SUBDIVISION AUTHORITY MINUTES

RE: Tentative plan of subdivision to create 10 single detached residential lots from NE 23-51-25-4 and SE 23-51-25-4, located west of 141 Street SW and south of Ellerslie Road;
HAYS RIDGE

RE: Tentative plan of subdivision to create 113 single detached residential lots, one (1) Municipal Reserve lot, and two (2) Public Utility lots, from NW 19-52-25-4 and SW 19-52-25-4; located south of Whitemud Drive NW and east of 215 Street NW;
GRANVILLE

SUBDIVISION CONDITIONS OF APPROVAL MAP

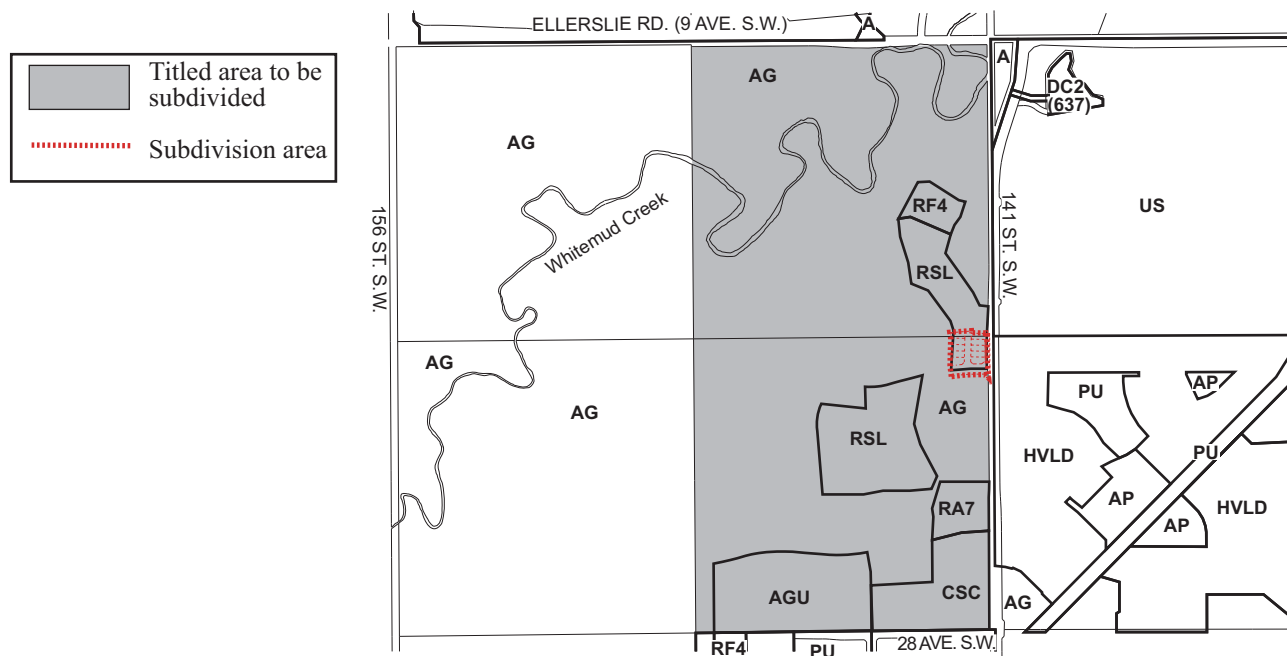
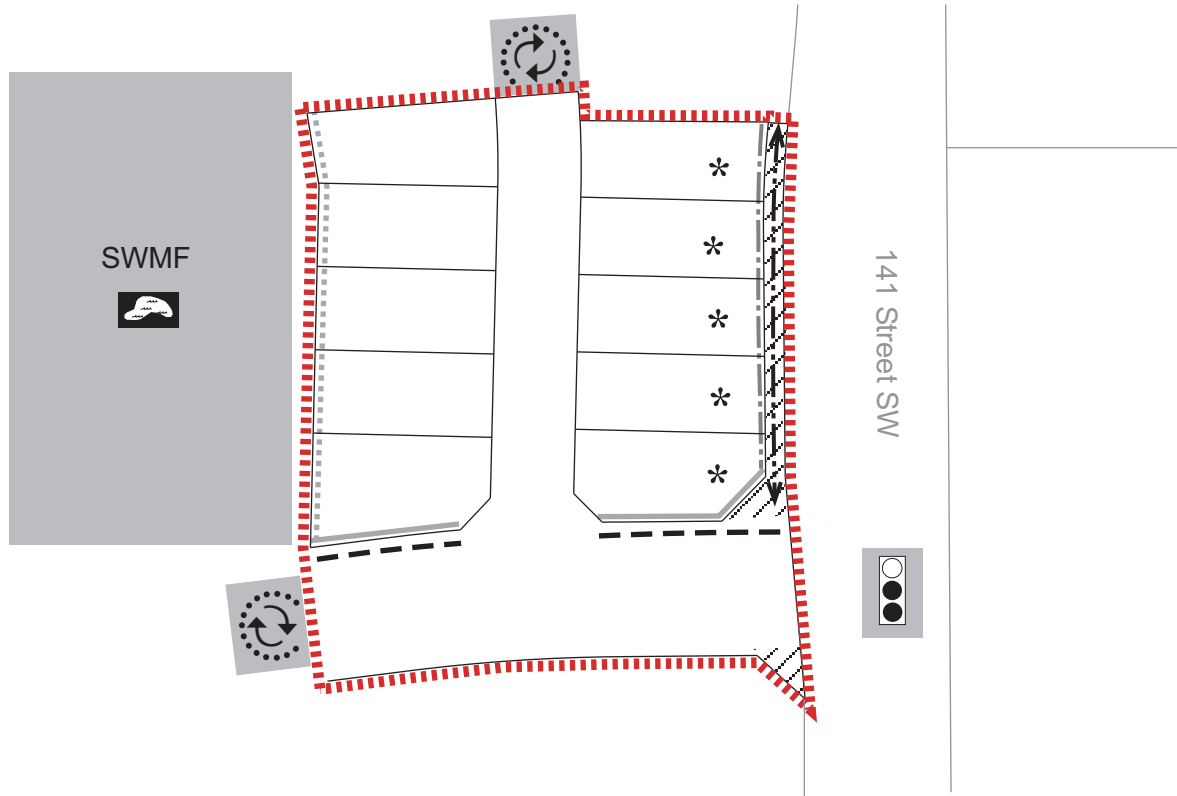
3. that the approved subdivision within the Hays Ridge Neighbourhood (File No. LDA12-0143) be registered prior to or concurrent with this application;
4. that the owner prepare a Restrictive Covenant in favour of the City of Edmonton that will be registered against all proposed lots backing onto the noise attenuation fence as shown on the "Conditions of Approval" map, Enclosure I;

5. that the owner dedicate 141 Street SW as road right-of-way to conform to an approved Concept Plan to the satisfaction of Transportation Services, as shown on the "Conditions of Approval" map, Enclosure I;

7. that the engineering drawings include the design and construction of the ultimate stormwater management facility in the location shown on the "Conditions of Approval" map, Enclosure I;

8. that the Hays Ridge Neighbourhood 11 Neighbourhood Design Report be submitted and approved, prior to the approval of engineering drawings;
9. that the owner construct a 3.0 m hard surface shared use path with "Shared Use" signage, lighting, bollards, and landscaping, as shown on the "Conditions of Approval" map, Enclosure I;

10. that the owner construct a 2.5 m hard surface sidewalk with lighting, bollards, and landscaping, as shown on the "Conditions of Approval" map, Enclosure I;

11. that the owner construct 12 m radius gravel surface temporary turnarounds with bollards or mini-barriers prior to CCC, to the satisfaction of Transportation Services, as shown on the "Conditions of Approval" map, Enclosure I;

12. that the owner pay for the installation of traffic lights at the intersection location, as shown on the "Conditions of Approval" map, Enclosure I. The City of Edmonton shall complete the signal design, and the City's Electrical Services Contractor must install the signal as per the agreement between the City of Edmonton and the Electrical Services Contractor. The timing of the traffic signal installation will be at the discretion and direction of Transportation Services. If traffic signals are not deemed warranted by Transportation Services within 5 years of the signing of the Servicing Agreement, the owner will be required to provide payment to the City of Edmonton for the installation of traffic signals at a later date to fulfill this obligation;

13. that a Noise Study be provided to confirm the noise attenuation required adjacent to 141 Street SW, in accordance with the City of Edmonton's Urban Noise Policy, and that the owner construct noise attenuation in accordance with the requirements outlined in a Noise Study. At a minimum, the owner must construct a 1.8 m noise attenuation fence as per the City of Edmonton's Roadway Design and Construction Standards Drawing No. 5205, within residential property lines for all lots backing onto 141 Street SW to the satisfaction of Transportation Services, as shown on the "Conditions of Approval" map, Enclosure I;

14. that the owner construct all fences wholly within private property lands, to the satisfaction of the Transportation Services and Sustainable Development, as shown on the "Conditions of Approval" map, Enclosure I; and
15. that the owner is responsible for the design, landscaping and construction within the Public Utility Lots, utility rights-of-way, road islands, boulevards, medians, walkways, and Municipal Reserve parcels, to the satisfaction of Infrastructure Services, Transportation Services, and Sustainable Development.
